|  HARTING Pushing Performance | HARTING Product Change Notification | PCN |

PCN/23/014/C+N-US

Product Range: Han-Modular®

Title: Han® DD Quad Module New Plastic Material

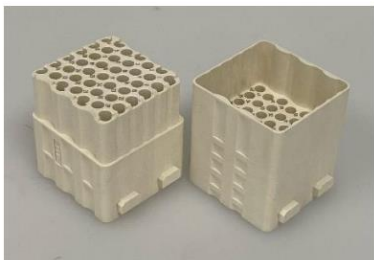
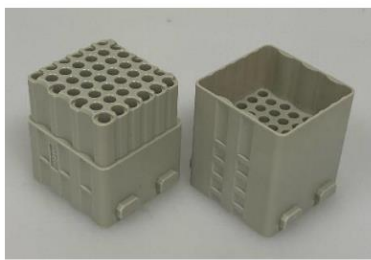
| 1. Concerned Part Numbers | |
|--|--|
| <p>The plastic material of the Han® DD Quad module will be changed from LCP to PC (polycarbonate) which is the same PC that is used for the other Han-Modular® modules.</p> <div> <div> <p>Photo of present Han® DD Quad module</p>  <p>Revision level 01 02</p> </div> <div> <p>Photo of new Han® DD Quad module</p>  <p>02 03</p> </div> </div> | |

| 1. Concerned Part Numbers | |
|--|--|
| <p>The change of plastic material has no impact on product specification, handling and application of the DD Quad modules.</p> <p>The UL approval of the new module is scheduled for April 2024.</p> | |
| New revision level | |
